CITY PLANNING COMMISSION
1231 "I" STREET, SUITE 200, SACRAMENTO, CA 95814

- APPLICATION:**
- A. Variance to allow landscaping without the required irrigation system for a 96 unit apartment complex on 5.3 ± vacant acres in the Multiple Family Residential-Review (R-2B-R) zone.
 - B. Modification of a Rezone and a Plan Review condition (P88-432) requiring a 3.5 foot turfed undulating berm within the 25 foot setback area to allow drought tolerant landscaping with no irrigation for a 96 unit apartment complex.

LOCATION: Northeast corner of 43rd Avenue and Riverside Boulevard

EXHIBIT D

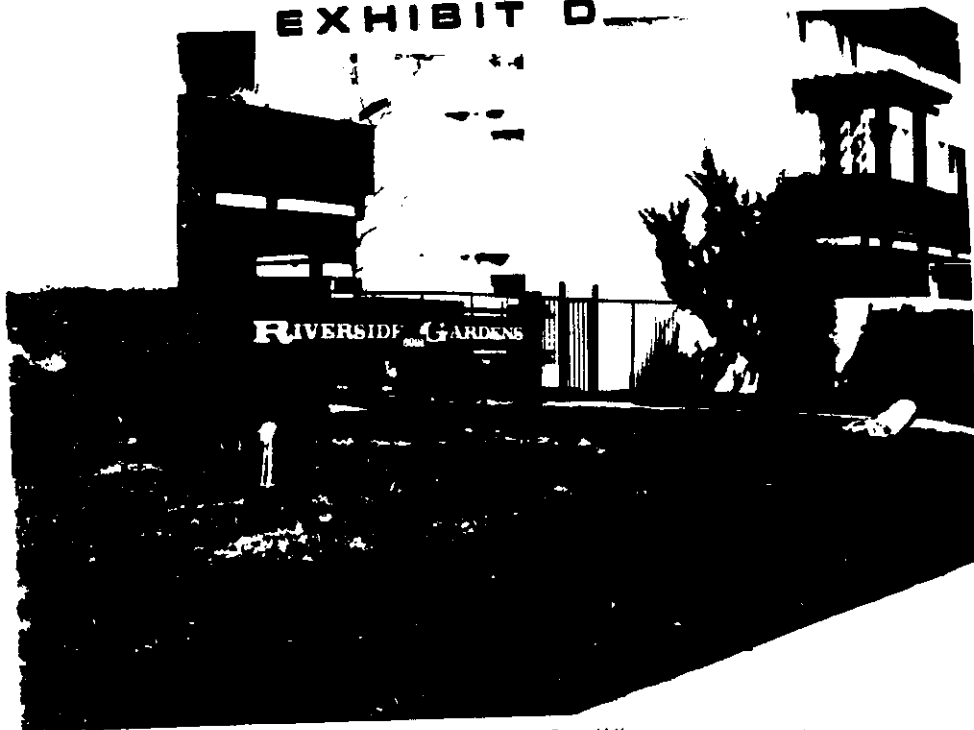
The surrounding areas around the subject site all have setback areas that are landscaped with grass and shrubs (see Exhibit D). In keeping with the original findings for the project which stated the proposed project would be compatible with the surrounding multiple family unit, staff recommends the applicant use a drought resistant tall fescue or rye sod as groundcover in the setback areas.

1. The applicant shall landscape the setback areas along 43rd Avenue and Riverside Boulevard with drought resistant landscaping, as submitted, to include sloping as necessary for proper drainage. The applicant shall use a drought resistant tall fescue or rye sod as ground cover in the setback areas. No bark, masonry rock, or other non-living cover will be the primary ground cover in the setback areas. The applicant shall submit revised landscaping plans for review and approval by the City's Landscape Architect and Planning Director prior to the issuance of building permits.

EXHIBIT F

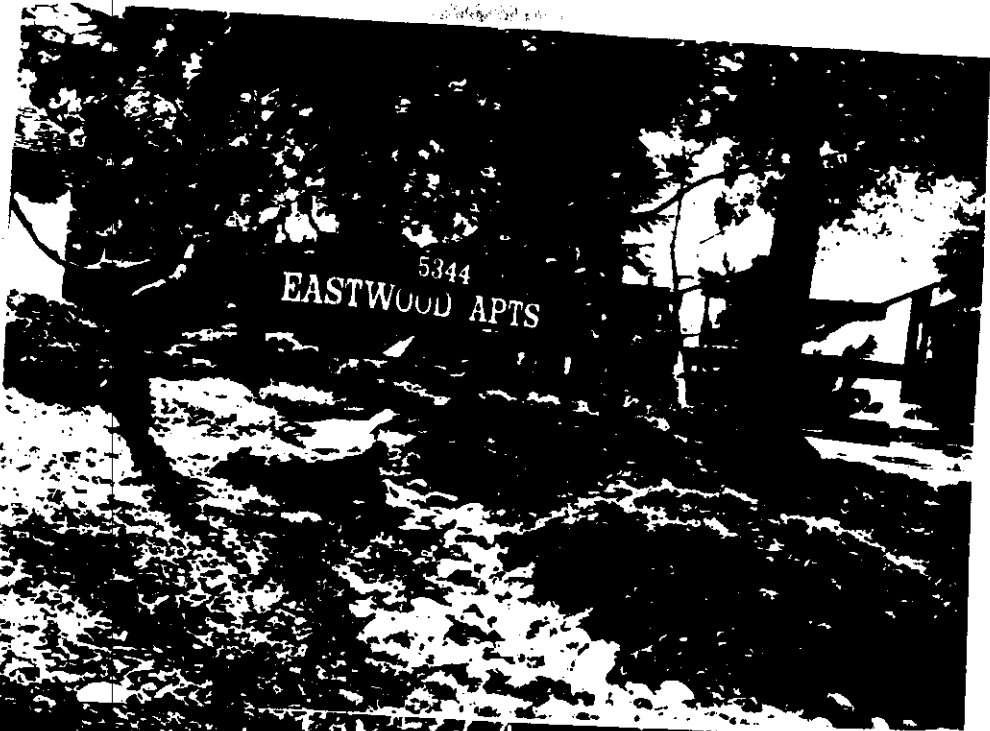
Staff visited the two sites in the county. The most important discovery was found at the Madison Square Gardens apartment site. At this site, a vast and intricate automatic drip irrigation system was in place and has been in place since the project's conception (see Exhibits E and F). The applicant used river rock as the primary ground cover in the setback areas and bark throughout the remainder of the complex in addition to the drought resistant plants, shrubs, and trees. The Eastwood Apartments did not have an irrigation system. The primary ground cover is bark. The site is poorly maintained with dead plants and weeds throughout the site (see Exhibits G and H). This site has only four types of vegetation which include palm trees, several types of juniper, nadina and pampas grass. There is evidence of many plants that have died and been removed with nothing replacing them. This site has been established longer and yet the growth of the plants appears minimal in comparison to the irrigated Madison Square Gardens site. The City's Landscape Architect believes the lack of irrigation and proper care of the Eastwood Site is the reason for the extreme difference between the two sites.

3. The revised landscape plan shall include a drip or bubbler irrigation system and Planning Staff shall inspect the site prior to issuance of Occupancy Certificate.
